FED. ROAD DIST. NO.	STATE	PROJ. NO.	FISCAL YEAR	SHEET NO.	TOTAL SHEETS
HAWAII	HAW.	I-H3-1(72)	1991	C.O. ADD. 7	521

TYPICAL ROADWAY SECTIONS
H3 KANEHOE INTERCHANGE

INTERSTATE ROUTE H-3
F.A.I. PROJ. NO. I-H3-1(72)

**TYPICAL RAMP
SECTIONS AND DETAILS**

FED. ROAD DIST. NO.	STATE	PROJ. NO.	FISCAL YEAR	SHEET NO.	TOTAL SHEETS
HAWAII	HAW.	I-H3-1(72)	1991	C.O. ADD. 10	521

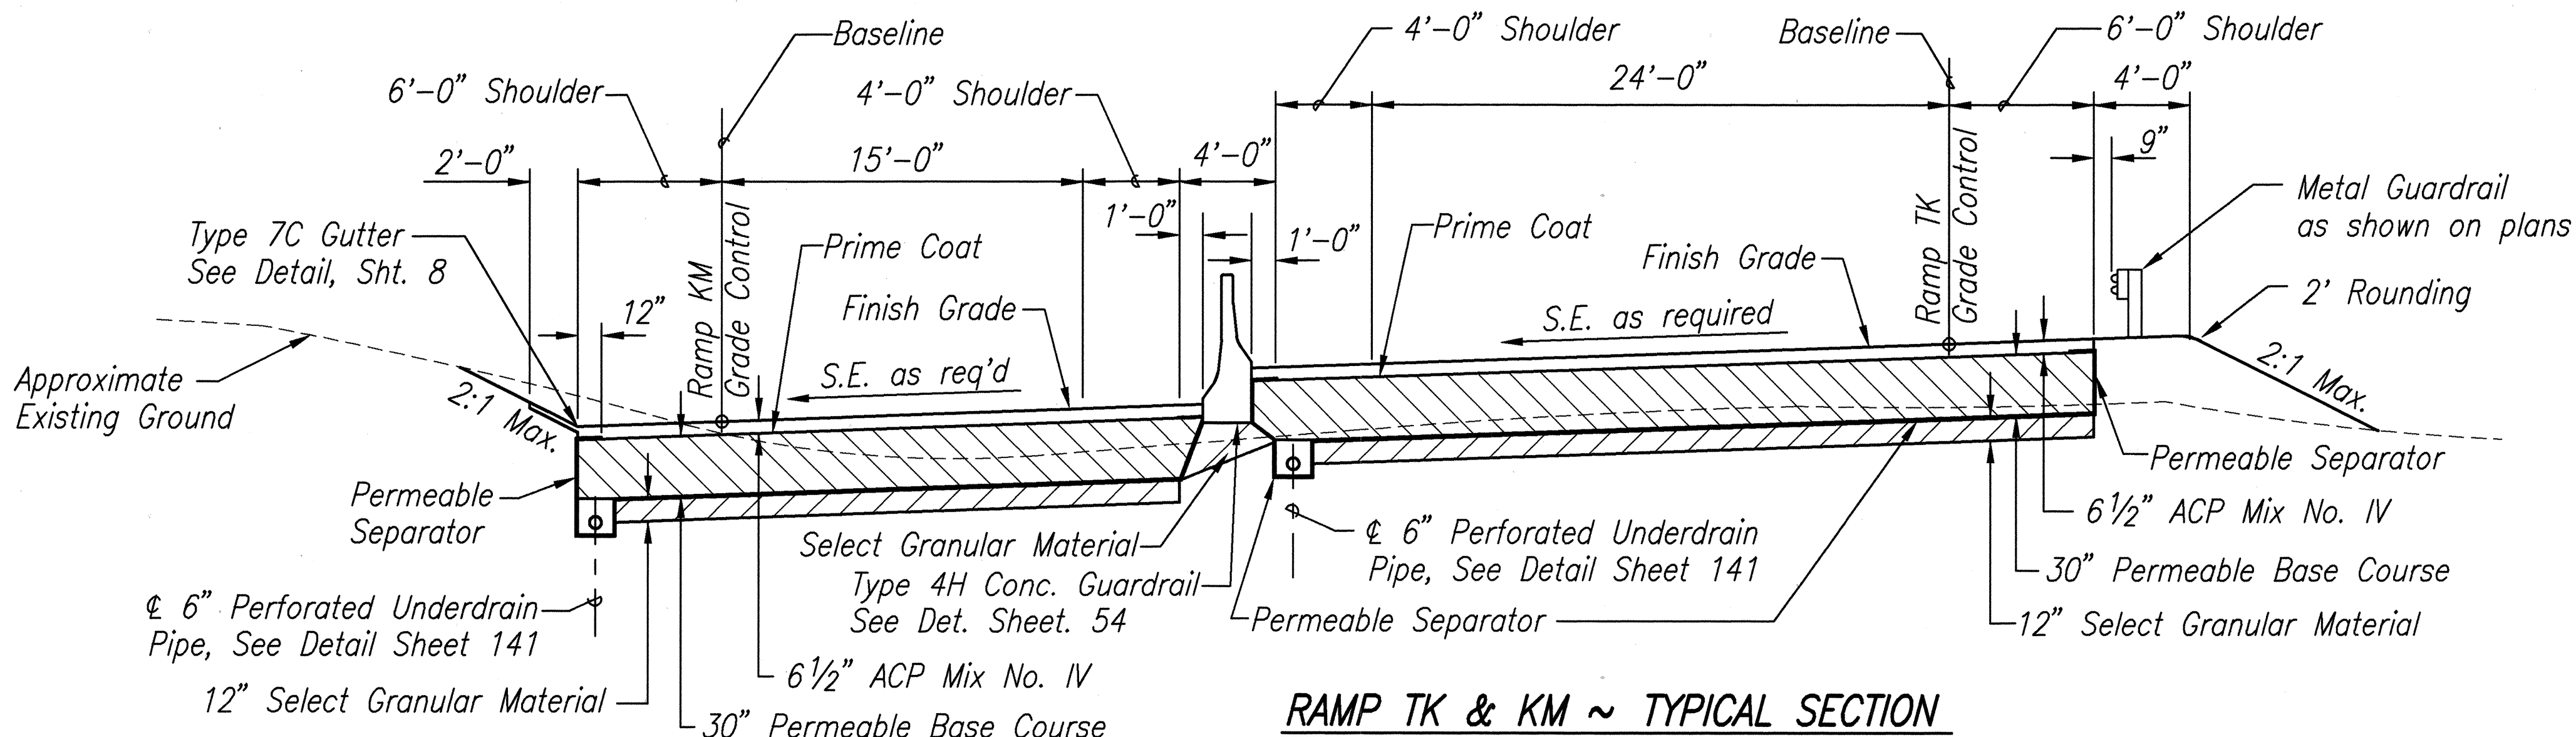
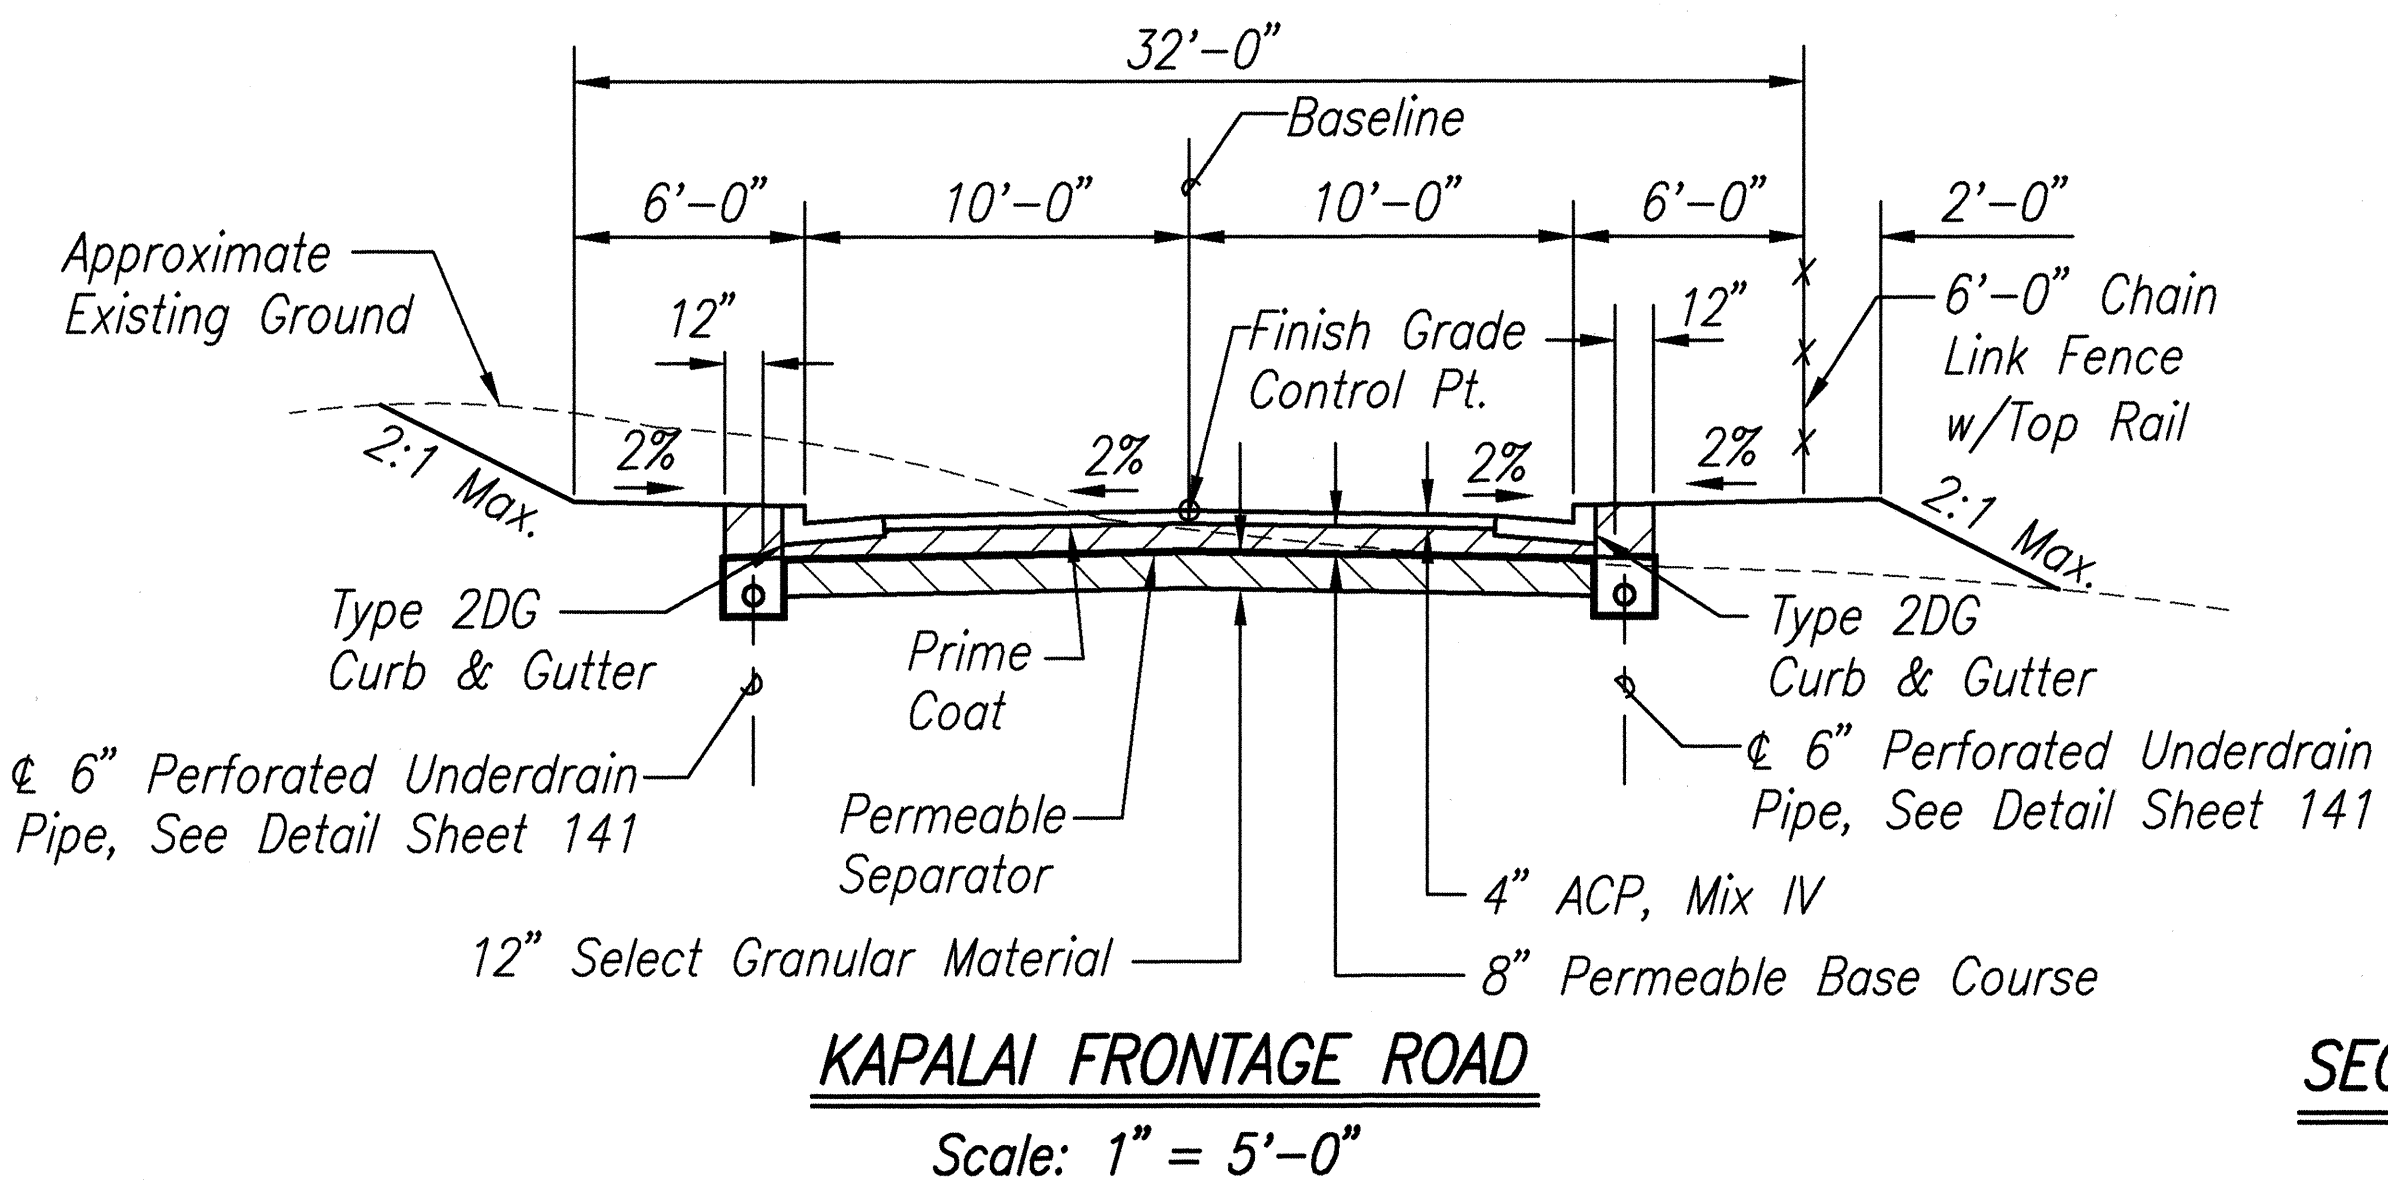
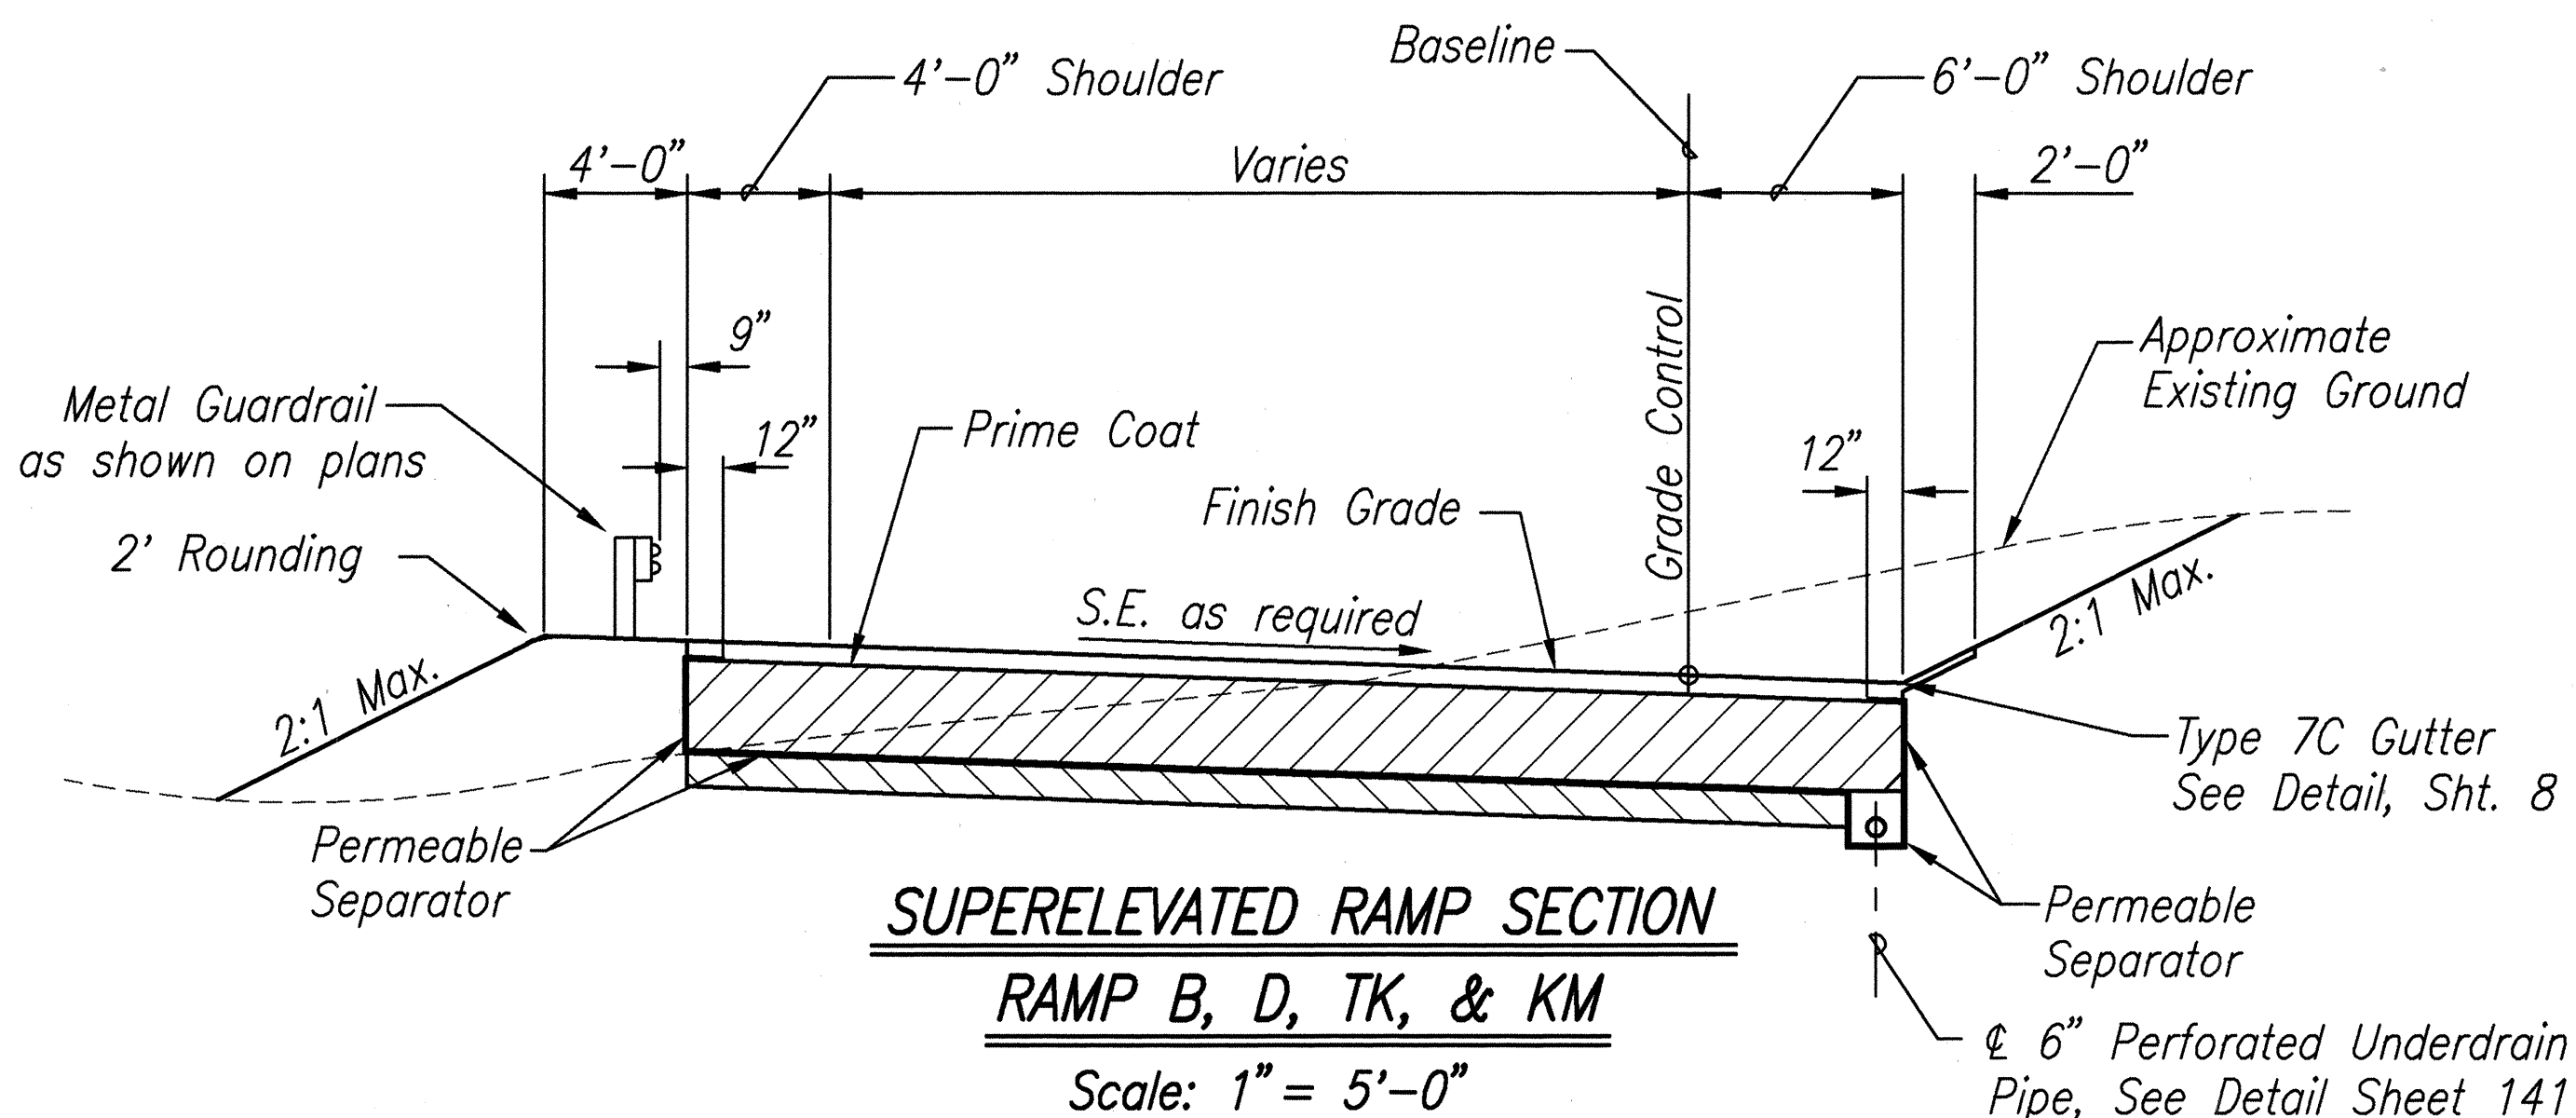
9/3/93	Revised Permeable Base Course to Select Granular Material under 4H Median Barrier @ Ramp TK & KM
3/15/93	Added Section for TK Sta. 18+50
2/17/93	Revised Ramp TK & KM typical section; Extended pavement to Median Barrier.
2/21/92	Revised Ramp TK/KM typical section from type 7 to type 7C Gutter.
1/27/92	Revised Type 2 & 2C Gutter to Type 7 & 7C Gutter, respectively.
DATE	REVISION
